PARK CITY MUNICIPAL CORPORATION
ADMINISTRATIVE PUBLIC MEETING MINUTES
PLANNING DEPARTMENT
<https://us02web.zoom.us/j/88167820277>
March 6, 2025

949 Empire Avenue – Historic District Design Review – PL-24-06356 –
Proposing to Construct a New Single-Family Dwelling on a Vacant Lot in the Historic Residential – 1 Zoning District.

9. The below image identifies these Setbacks:

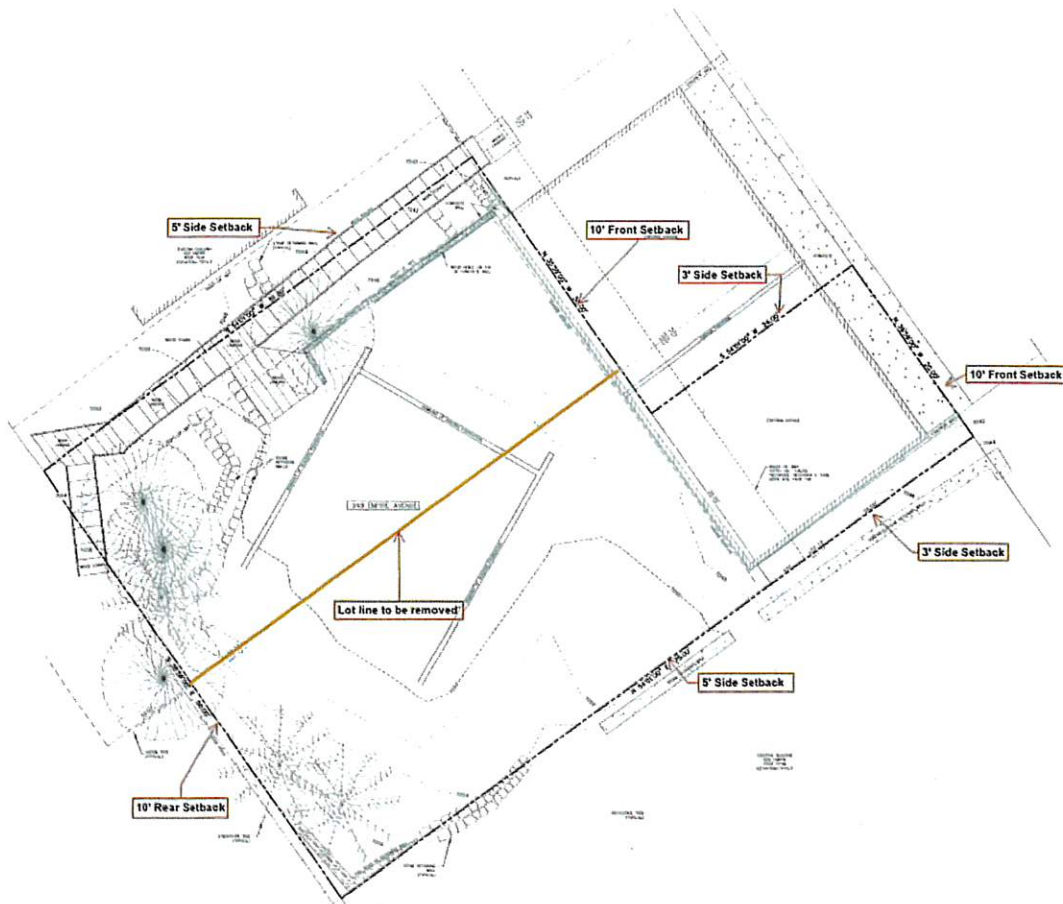
8. The Lot has six property lines that measure: 50', 51', 30', 24', 20', 75'. Due to the unusual Lot dimensions, the Planning Director made a determination regarding Setbacks:

- a. Two (2) three-foot (3') Side Setbacks;
 - b. Two (2) five-foot (5') Side Setbacks;
 - c. Two (2) ten foot (10') Front Setbacks;
 - d. One (1) ten foot (10') Rear Setback.
